**REPORT FOR: CROWE VALLEY CONSERVATION AUTHORITY WATERSHED ADVISORY BOARD**

**REGARDING: ONTARIO REGULATION 159/06, PERMIT APPLICATION NO. 080/23 BEING:  
A DWELLING, DECK AND SEPTIC SYSTEM LOCATED WITHIN THE CROWE LAKE  
FLOOD HAZARD.**

**DATE: MARCH 07, 2024**

### **Site Plan and Detailed Drawings**

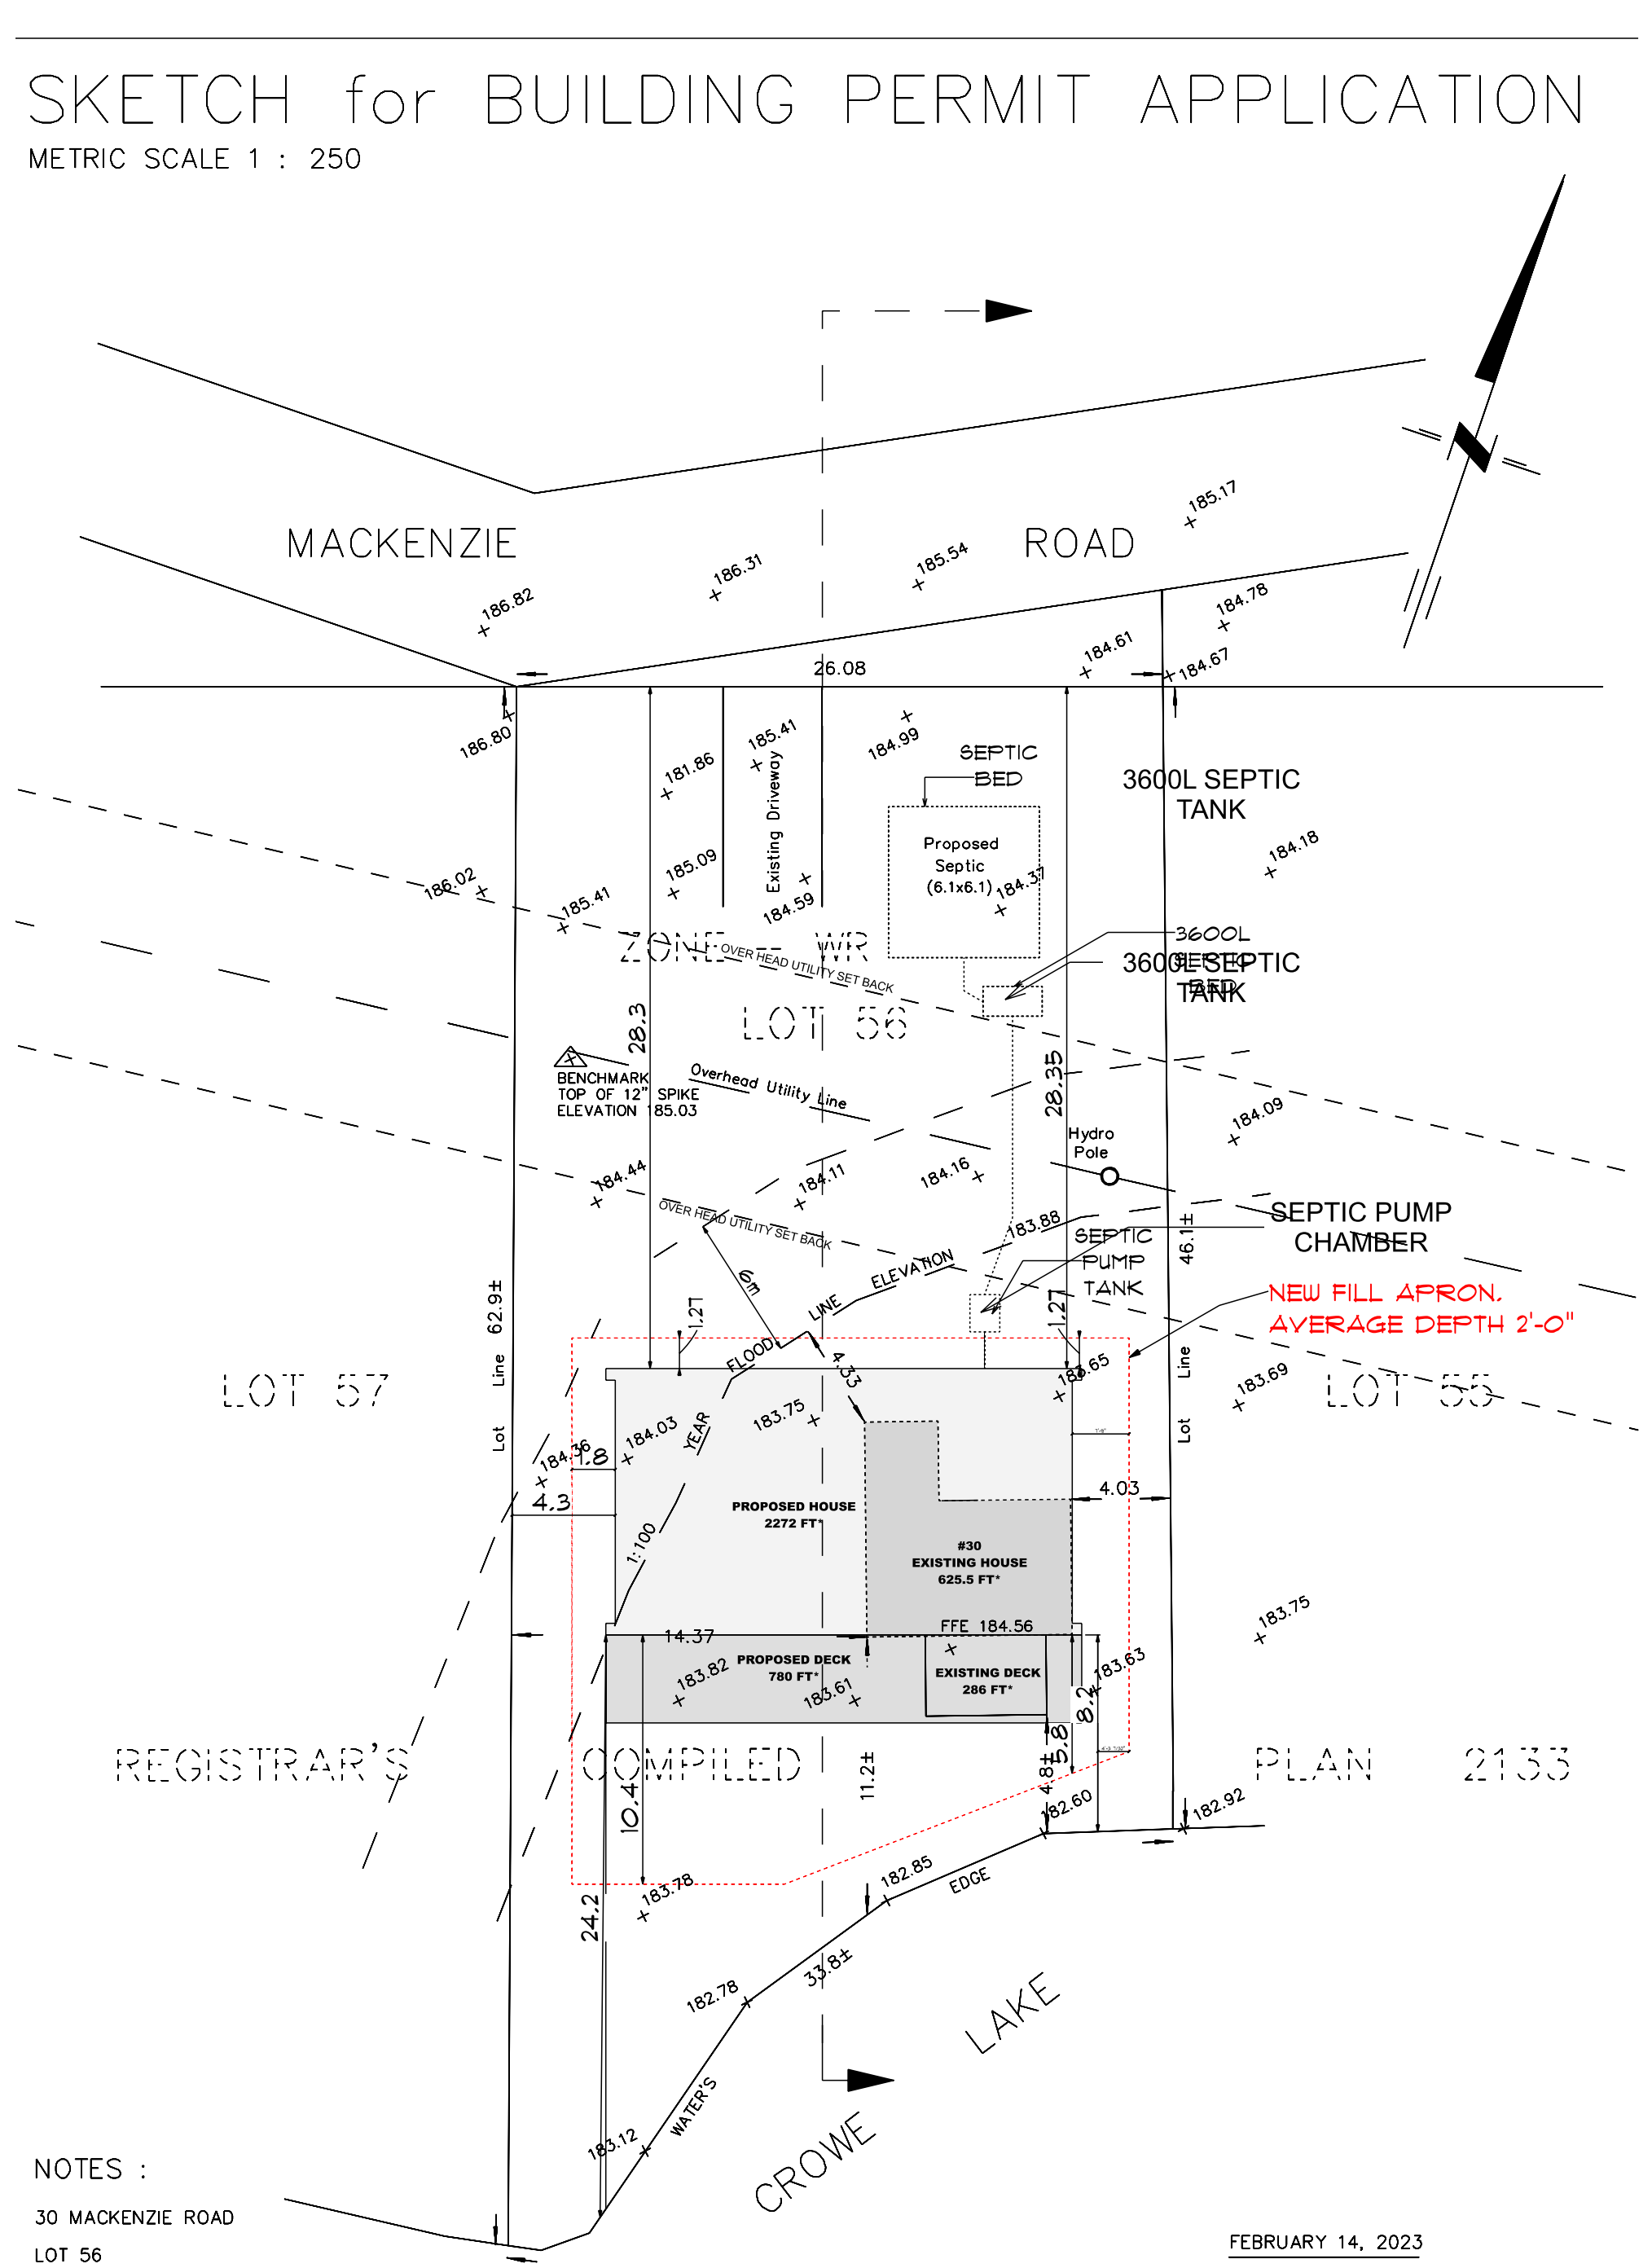
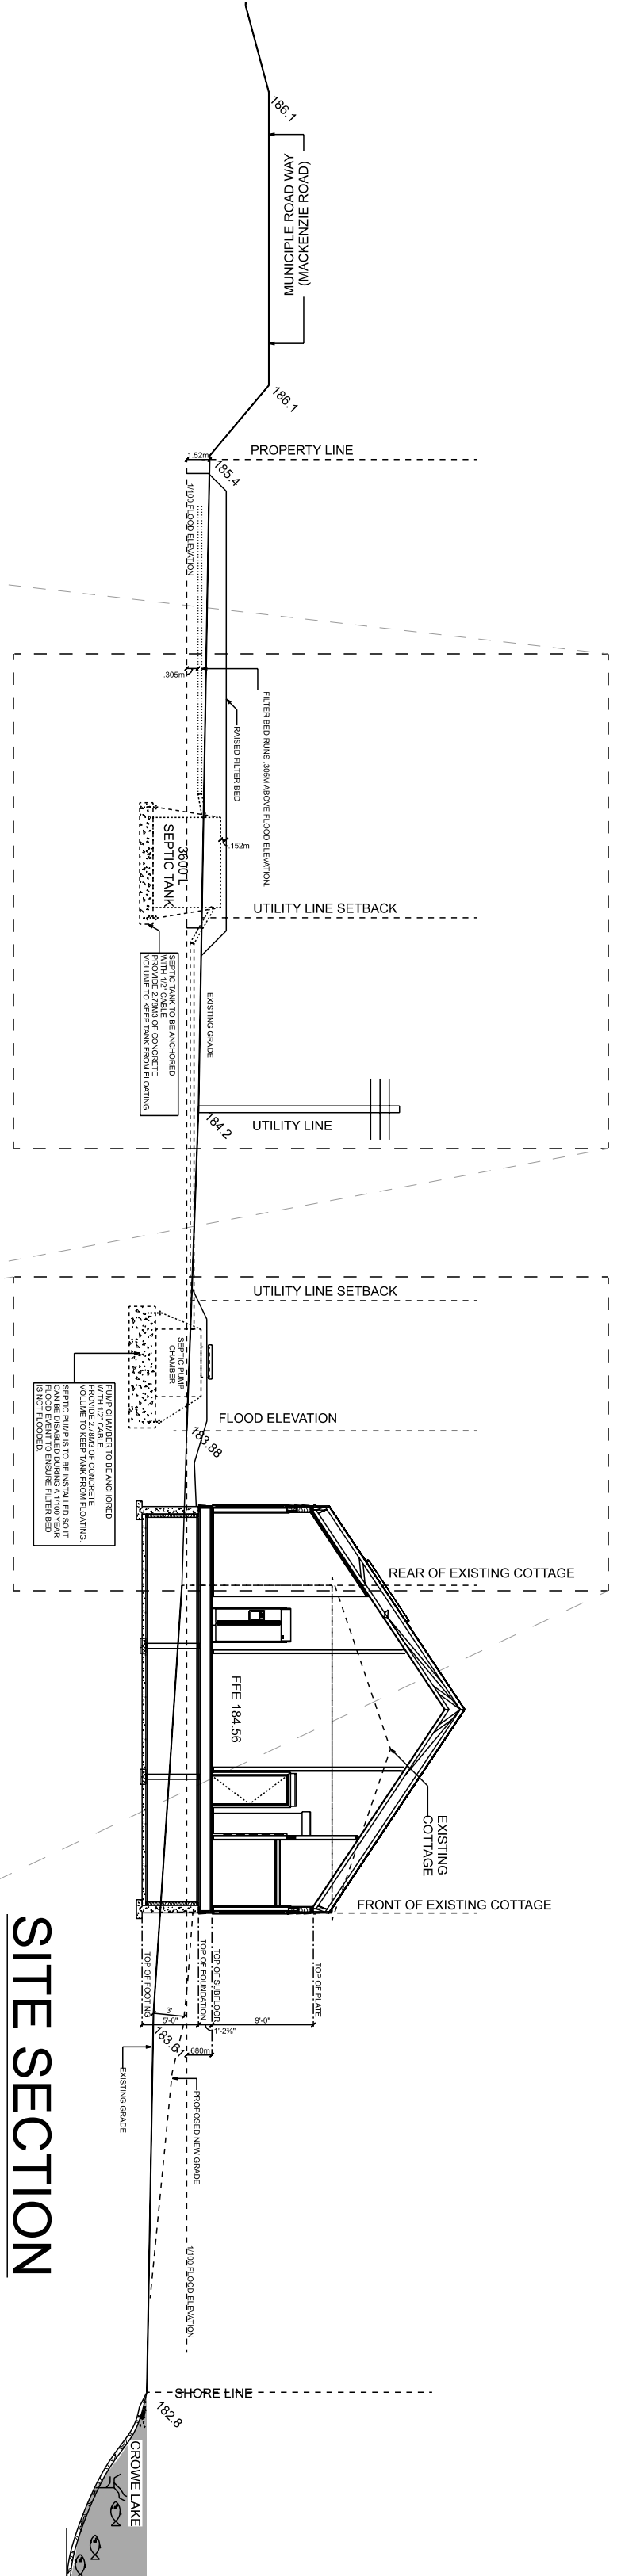
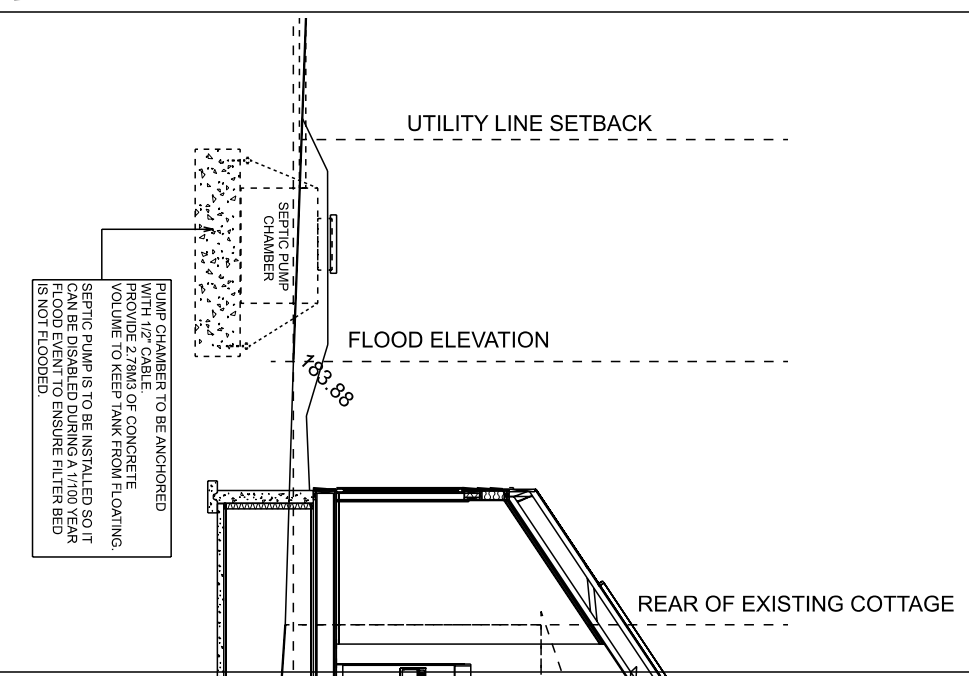
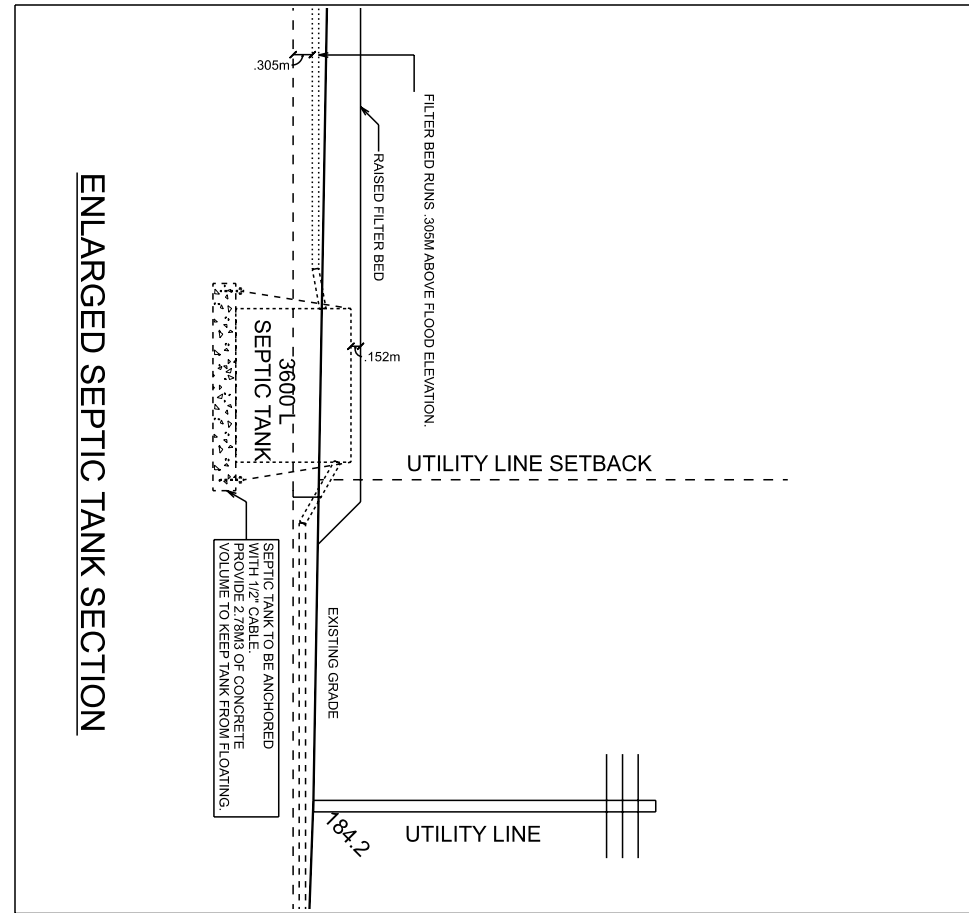
**The proposed development does not conform as it is not located a minimum of 6 metres beyond the greater of the floodplain OR the predicted meander belt width (erosion hazard) and will change drainage on the site and exacerbate flood hazard.**

The client is proposing to construct a 2,272 ft<sup>2</sup> house with a 760 ft<sup>2</sup> deck to upgrade their existing house on the lot. The final floor elevation for the building upgrade is 184.56m (CGVD28) per the Waterson Land Surveyors plan of survey. The existing and proposed structures are surrounded by existing buildings on both sides. CVC provided a regulatory 100-yr floodplain elevation of 183.88m for the property as indicated on the survey plan.

In a comparison of the regulatory water level to the existing grades (both elevations in CGVD28), the regulatory water level is an average of 0.4m above the existing ground within the vicinity of the proposed fill to accommodate the building improvements. A schematic of the proposed plan is attached. Note that the average fill on the plan is 2 ft, or 0.6m. This is greater than the 0.4m referenced above since the 0.6m represents the average *total* fill (i.e. including above the 100-yr water level).

We also note that the survey plan shows the final floor elevation is 184.56m. Since this is more than 0.6m above the 100-yr water level of 183.88m, we have no concerns regarding the proposed final floor elevation.
